Oregon State University
Construction Contract Administration
ITB 198689 – DIXON CHILLER REPLACEMENT RE-BID

ADDENDUM NO. 1

Client: OREGON STATE UNIVERSITY
 CORVALLIS, OREGON
 Project Title: DIXON RECREATION CENTER CHILLER REPLACEMENT AND HVAC UPGRADES

1 BASEMENT FLOOR PLAN - SECTOR A - MECHANICAL
M1.01 SCALE: 1/8" = 1'-0"

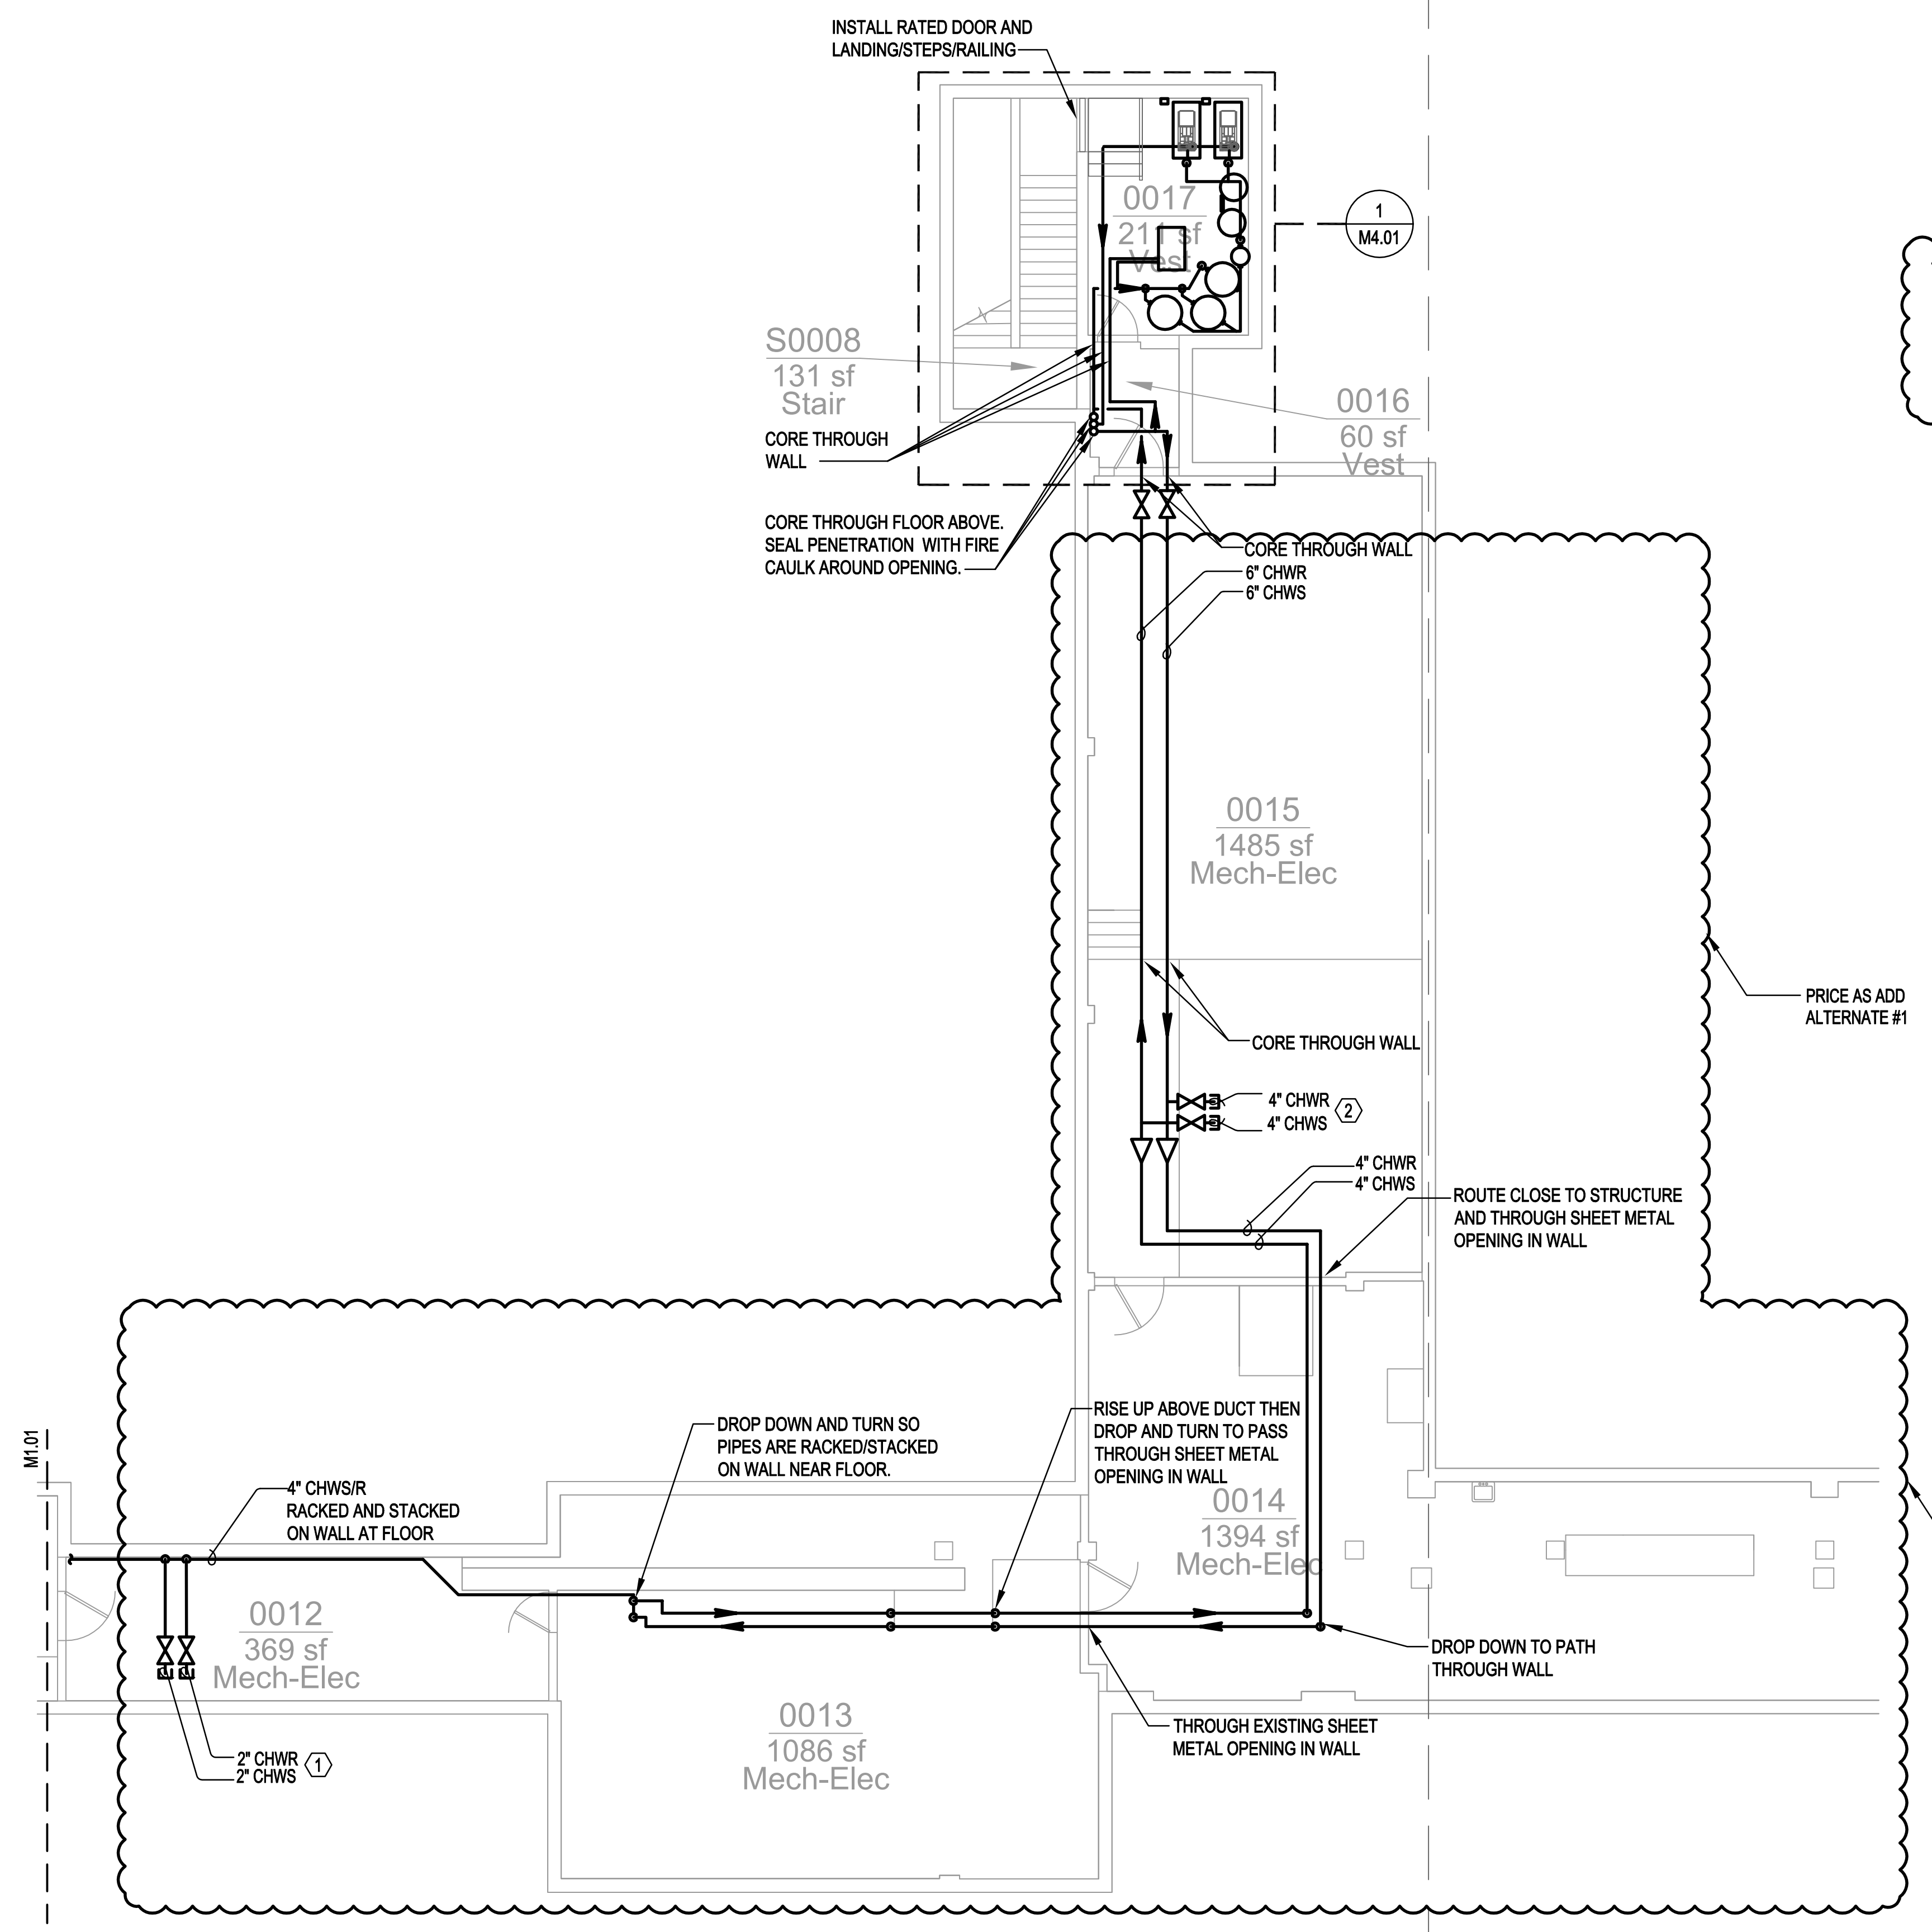
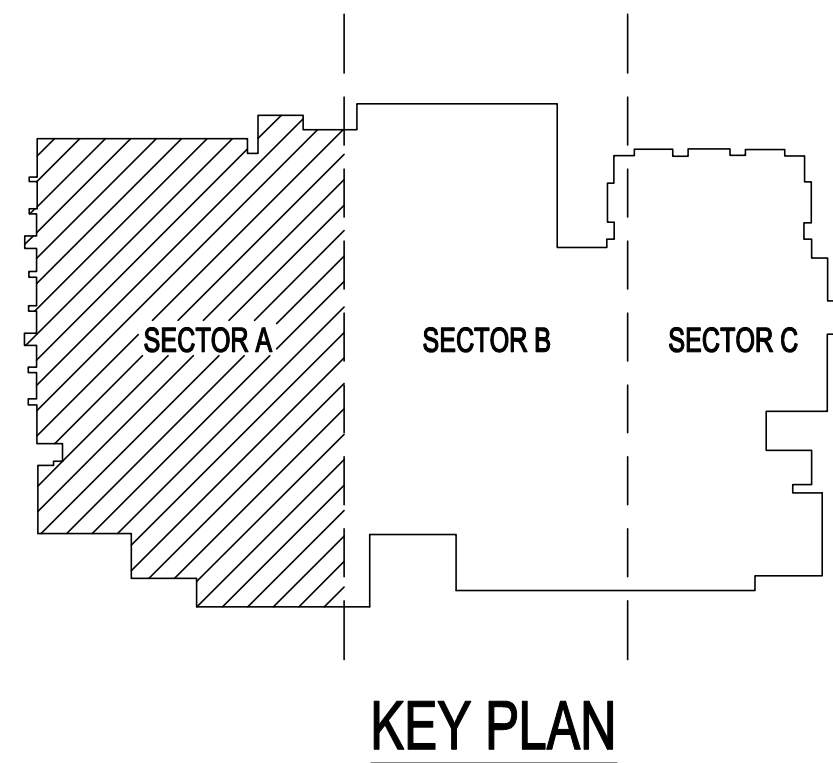
PRICE AS ADD ALTERNATE #1

1 BASEMENT FLOOR PLAN - SECTOR B - MECHANICAL
 M1.02 SCALE: 1/8" = 1'-0"

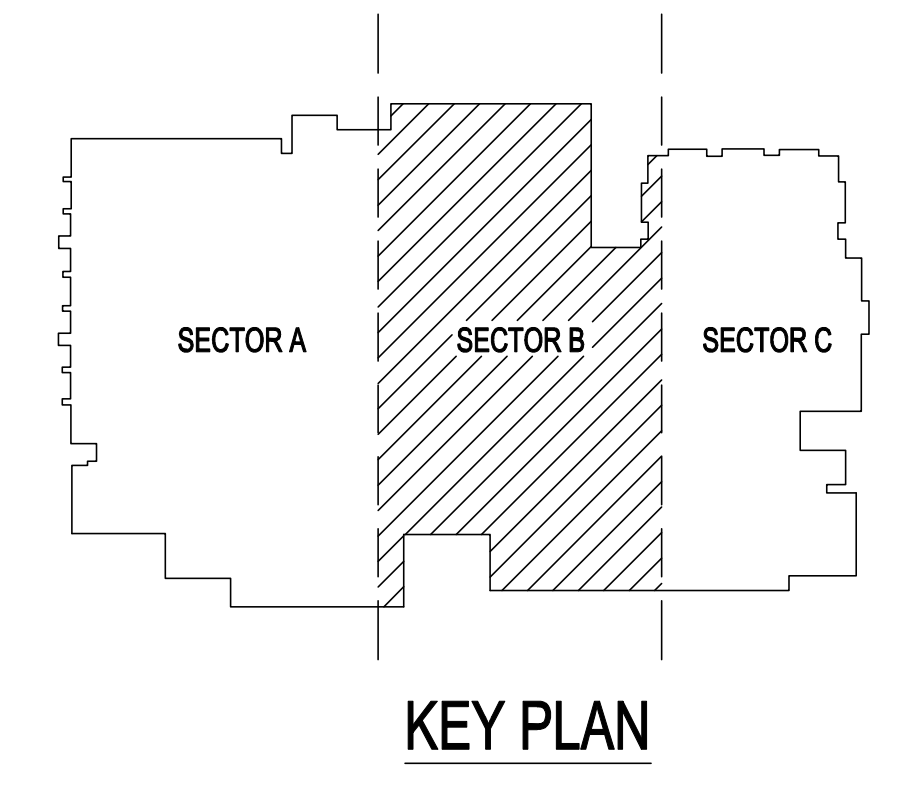
PRICE AS ADD ALTERNATE #1

PRICE AS ADD ALTERNATE #1

PRICE AS ADD ALTERNATE #1
